REMARKS

Amendment To Claims

FIG. 2

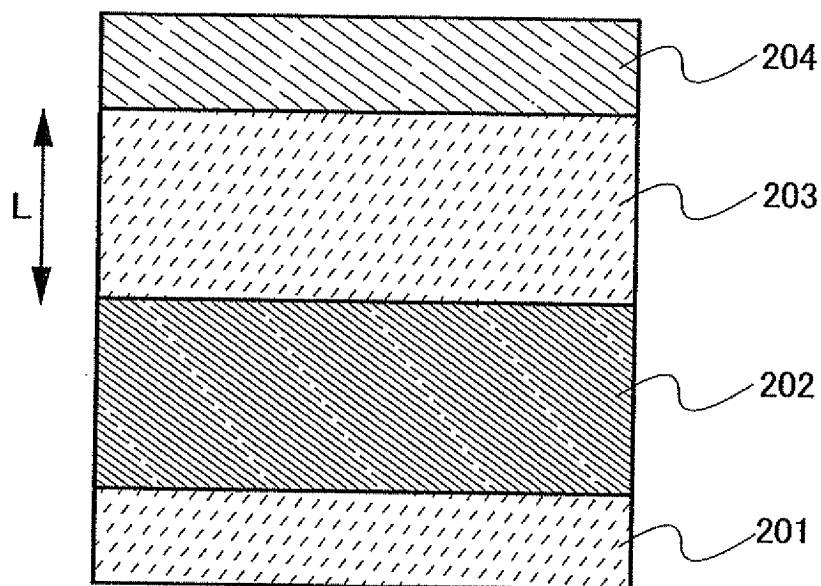
In the Office Action, the Examiner is requesting that Fig. 2 be labeled "Prior Art." Accordingly, Applicants are amending Fig. 2 to add the legend "Prior Art." In light of this amendment, it is respectfully requested that this objection be withdrawn.

Prior Art
